Re: WBI Energy Transmission, Inc.  
North Bakken Expansion Project  
Docket Nos. CP20-52-000 and CP20-52-001  
Variance Request for Project Modification

# North Bakken Expansion Project Variance Request Form

Variance Request Number: V32

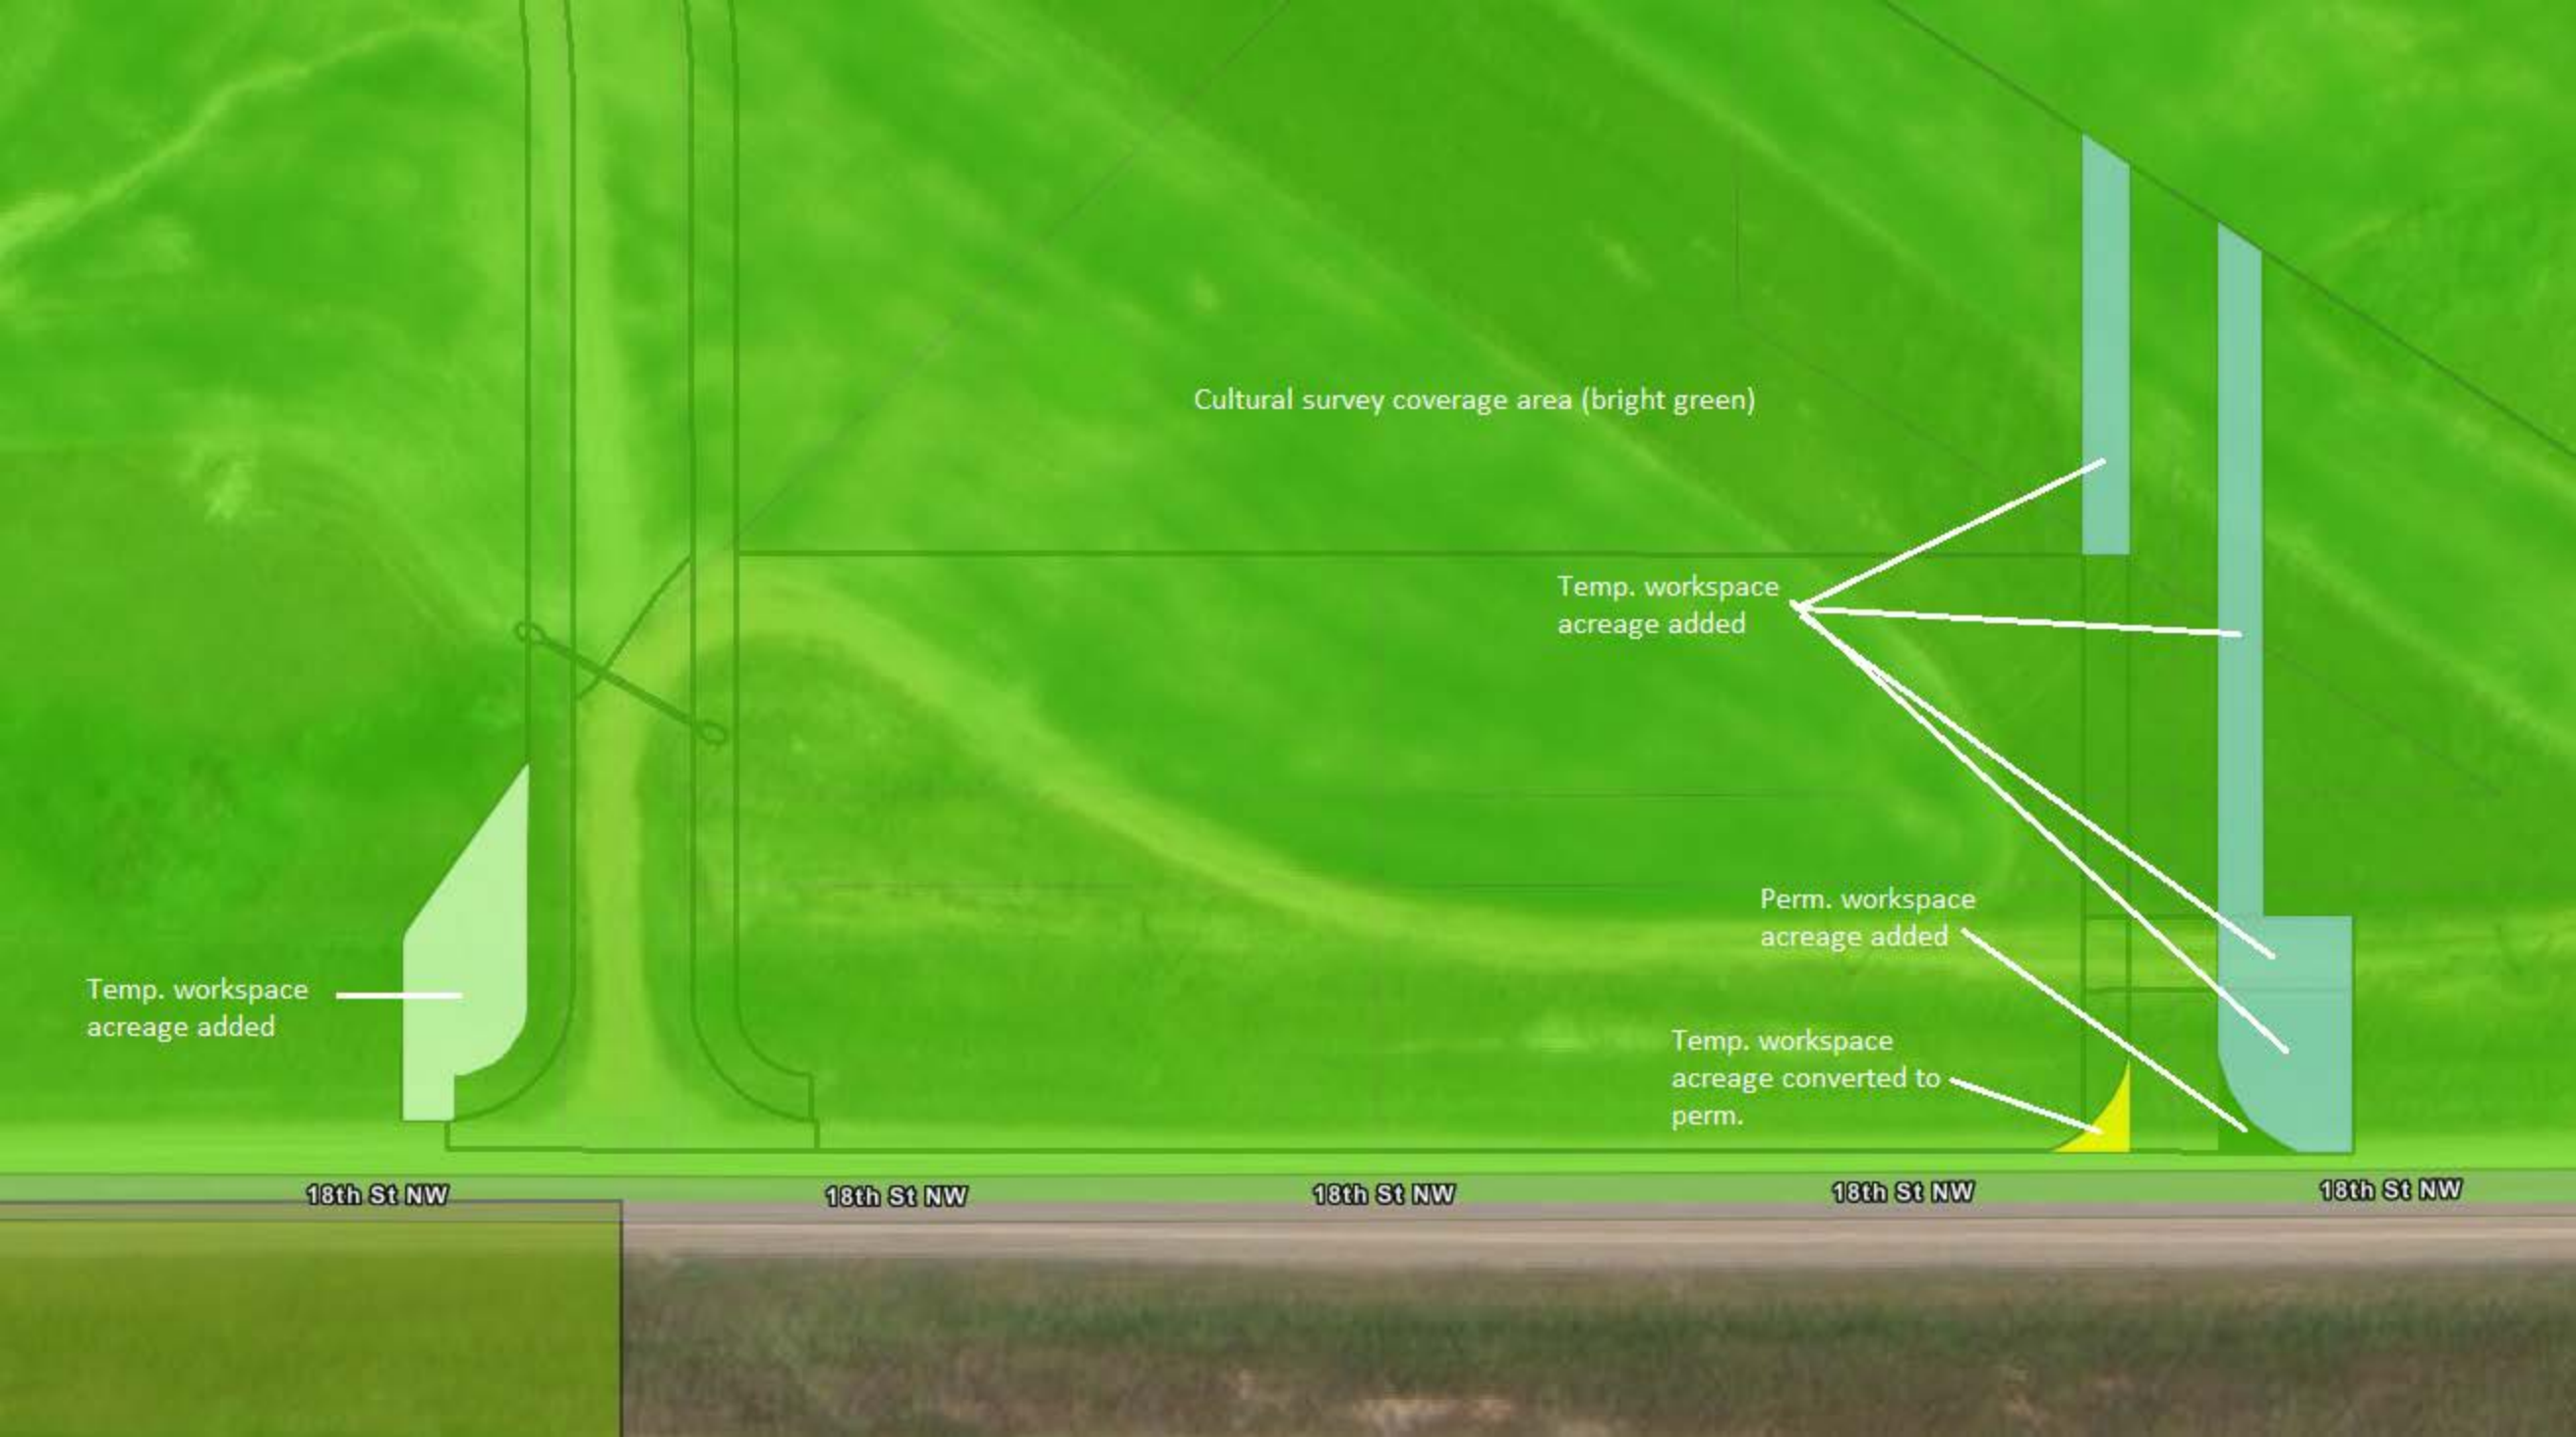
Temp. workspace added - 0.08

Temp. workspace converted to perm. - 0.01

Temp. workspace added for access road slope - 0.13

Temp. workspace added for road approach slope - 0.08

Perm. workspace added 0.01
